**Re: 657 - 769 Mamre Road, Kemps Creek (SSD 9522 MOD 2)
NSW Planning Industry & Environment – Letter dated 24 December 2021**

**Kemps Creek Warehouse, Logistics and Industrial Facilities Hub (SSD-9522-Mod-2)
Request for additional information**

**Re: 657 - 769 Mamre Road, Kemps Creek
"The Yards" - SSD 9522 Mod 2**

DRAWING No	C013362.00- DA03	ISSUE	A
------------	------------------	-------	---

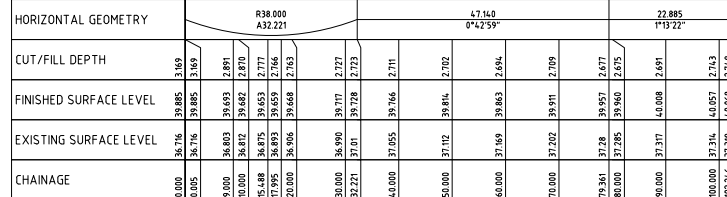
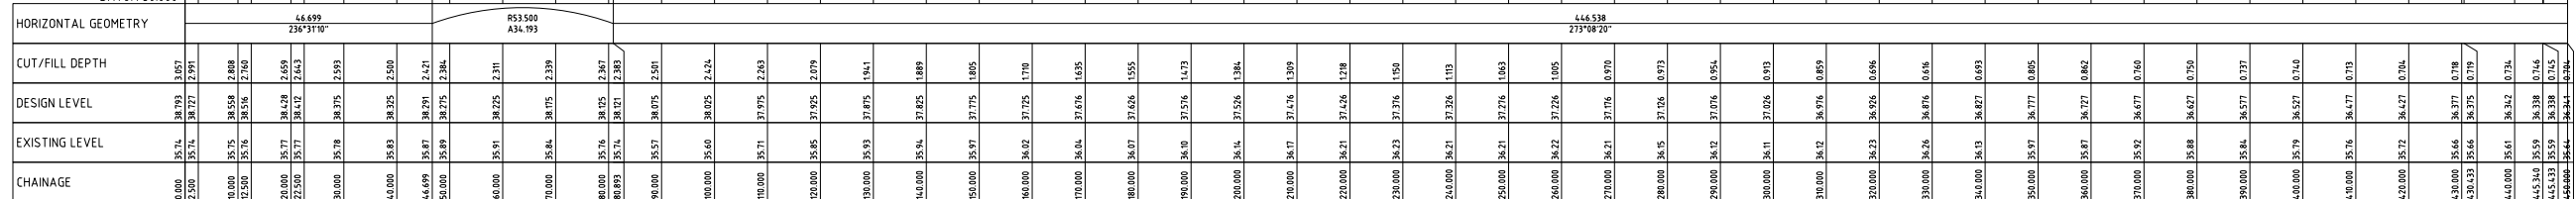
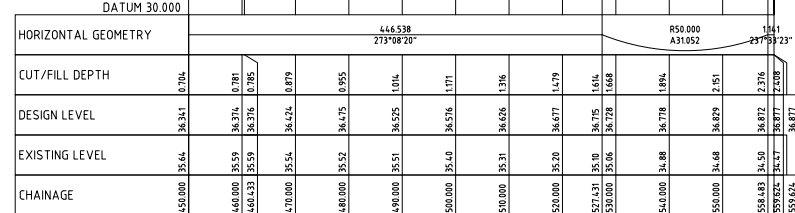
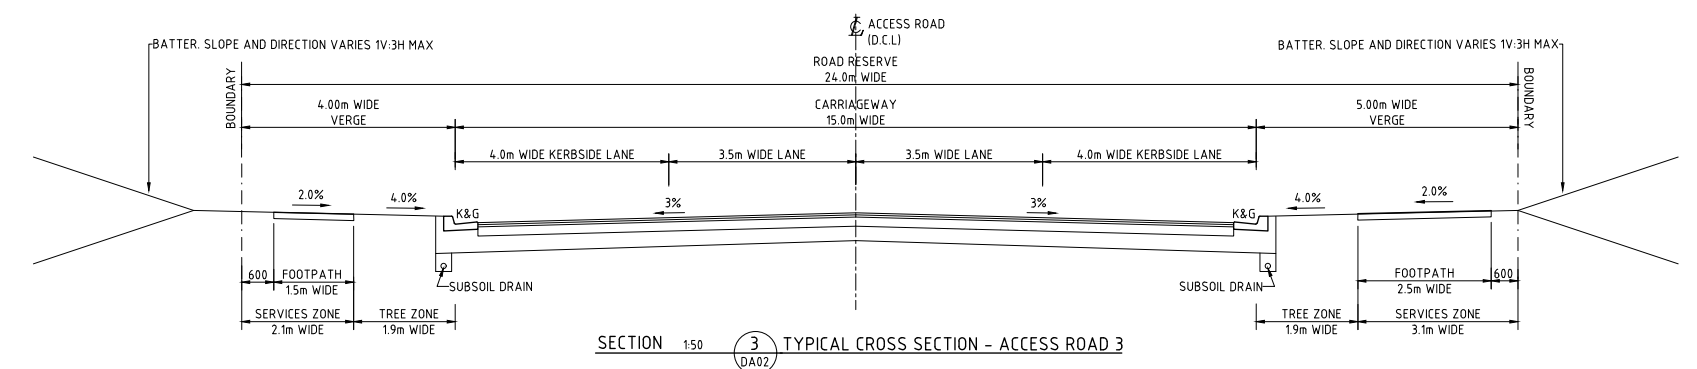
- The proposed amendments to the road reserve, as summarised in the table titled 'Estate Road Cross Section per SSD 9522' on page 14 of the Modification Report dated 19 October 2021, have not been modified in the civil drawings. Drawing CO13362.00 – DA 04 Issue B does not depict the modified road widths (Section 2). This error is carried into other civil drawings (CO13362.00 – DA08 Issue C) used in the swept path analysis. These errors need to be addressed and the swept path analysis reassessed with the agreed road widths.

No.	Item and Response
1)	<i>The proposed amendments to the road reserve, as summarised in the table titled 'Estate Road Cross Section per SSD 9522' on page 14 of the Modification Report dated 19 October 2021, have not been modified in the civil drawings. Drawing CO13362.00 – DA 04 Issue B does not depict the modified road widths (Section 2). This error is carried into other civil drawings (CO13362.00 – DA08 Issue C) used in the swept path analysis. These errors need to be addressed and the swept path analysis reassessed with the agreed road widths.</i> <u>Response</u> We provide updated letter and sectional drawing to confirm the modelled swept paths and agreed road widths. We note the road widths assessed are consistent with the Final Mamre Road Precinct DCP, noting Access Road 2 depicts a modified Industrial road with an additional 1.2m wide central median as requested by Penrith City Council. The report has been revised to confirm the road dimension for the Industrial Road Type 1, and cul-de-sac cul-se-sac as per the dimensions reflected on Section 2 & 3 of drawing CO13362.00-DA04 Issue C. The road cross section and road layout assessed (including the turning paths on drawing CO13362.00-DA08 Issue C) are consistent with the noted amended Table 2 as agreed with Council and the Final Mamre DCP.
